02-2017 LATEST REVISION DATE	 APPROVED BY BRIDGE ENGINEER	 STANDARD DESIGN - 40' ROADWAY, 3 SPAN BRIDGES ROLLED STEEL BEAM BRIDGES OCTOBER, 2014

0° SKEW FRAMING PLAN

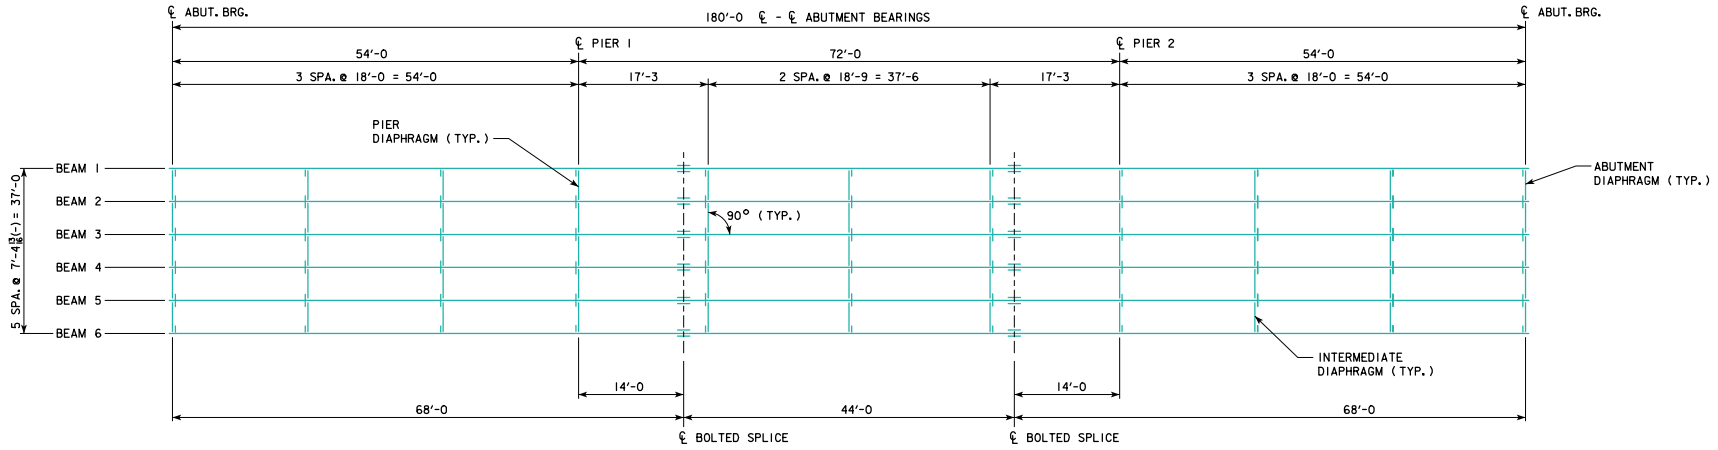
REVISED 02-2017 - CHANGED DIAPHRAGM SPACING IN ZERO SKEW FRAMING PLAN (WAS 4 SPACED AT 18'-0" IN 72'-0" CENTER SPAN, CHANGED DIAPHRAGM SPACING IN SKEWED FRAMING PLAN (WAS 4 SPACED AT 18'-0" IN 72'-0" CENTER SPAN, ADDED DIAPHRAGMS TO SKEWED FRAMING PLAN IN OUTER BAYS, BETWEEN BEAMS 1 & 2 AND 5 & 6 OF 72'-0" CENTER SPAN, 9'-0" FROM PIER CENTERLINES.
